TRANSMITTAL COVER SHEET

DATE: 21 June, 2024
TO: ALL PLAN HOLDERS OF RECORD
FROM: HUNTER SWATEK, AIA, PROJECT MANAGER
PROJECT: RAINBOW CITY RECREATION CENTER
GMC PROJECT NO. ABHM230021
RE: ADDENDUM NO. 3 AND
ACKNOWLEDGEMENT OF RECEIPT OF ADDENDUM NO. 3

ADDENDUM NUMBER 03

**PROJECT: RAINBOW CITY RECREATION CENTER
GM&C PROJECT NO. ABHM230021**

FILTER EQUIPMENT BUILDING PLAN
 SCALE: 1/4" = 1'-0"

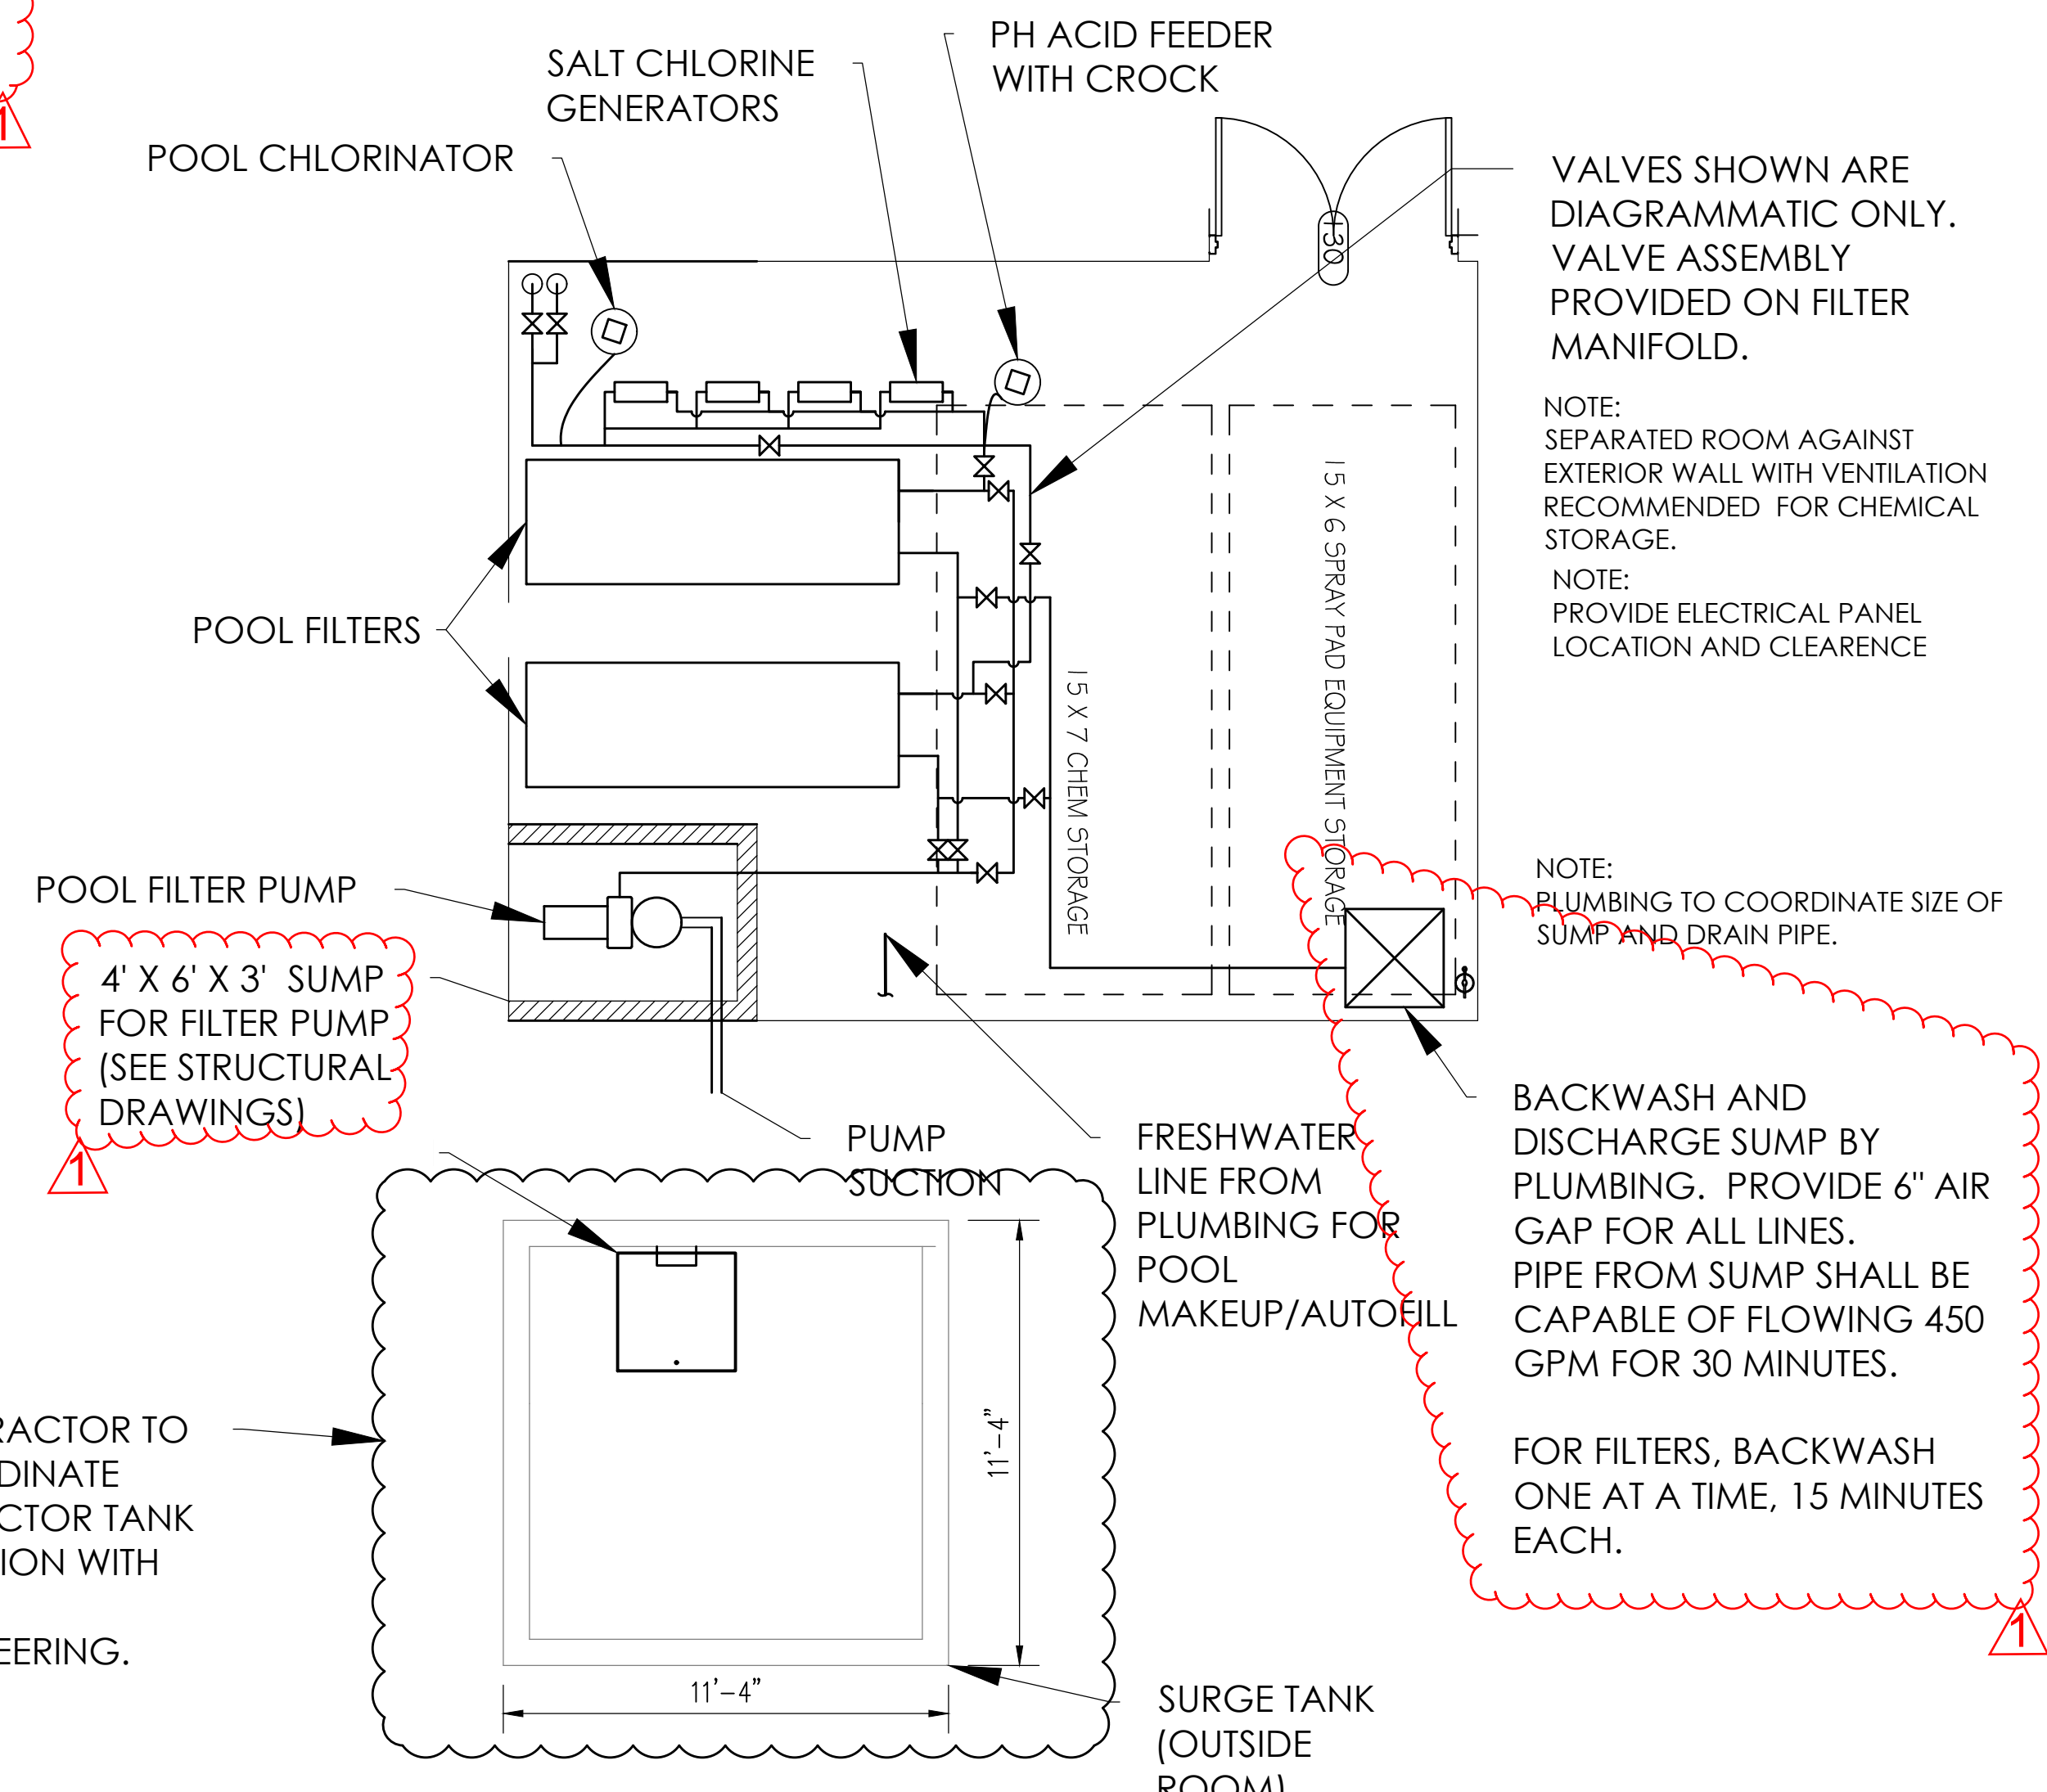
- b. REVISED Discharge pump tag
 - c. ADDED Pool filter sump along with 8" storm piping connecting to the 6" FS
- FF. SP1.01, SP1.02, SP2.01, SP2.02, SP2.03, SP2.04 – Pool Addendum 03**
- a. Pool main drains have been updated from (3) 24"x24" Drains to (1) 18"x36" Drain.
 - b. Note added on Pool reinforcement.
 - c. Note added regarding gutter warranty requirement.
 - d. Note added regarding alternate vendors requirement.
 - e. Specifications sheets have been provided for pool.

The pool designer called out the rebar spacing for the wall but not the floor. See SP1.01, wall detail. Is the floor rebar also 9" OC or different? It appears to be different, please advise	3	See updated Pool Drawings
	Specification Section 12 6613, Part 2.02 A requires seating to be manually operated. However, Part 2.02, B 6 requires electrically operated. Please clarify.	3	All telescoping bleachers to be manually operated.
	Porter is specified for the Gymnasium Equipment. However, they are not specified for Section 116653-Gymnasium Dividers. Do they need to submit a Substitution Request to be allowed to bid the Gymnasium Dividers? Usually Gymnasium Equipment and Dividers are supplied by the same vendor.	3	Porter is approved for both gymnasium equipment and dividers.
	The specifications are calling for the metals to be a 3-coat finish. The supplier just reached out and said that we could not get a quote on this due to the size, we would not meet the minimum order quantity for special finishes. Please advise if we should quote the standard 2-coat finish.	3	The metal panels in 07 4291 can be finished in a 2-coat Fluoropolymer (Kynar) finish
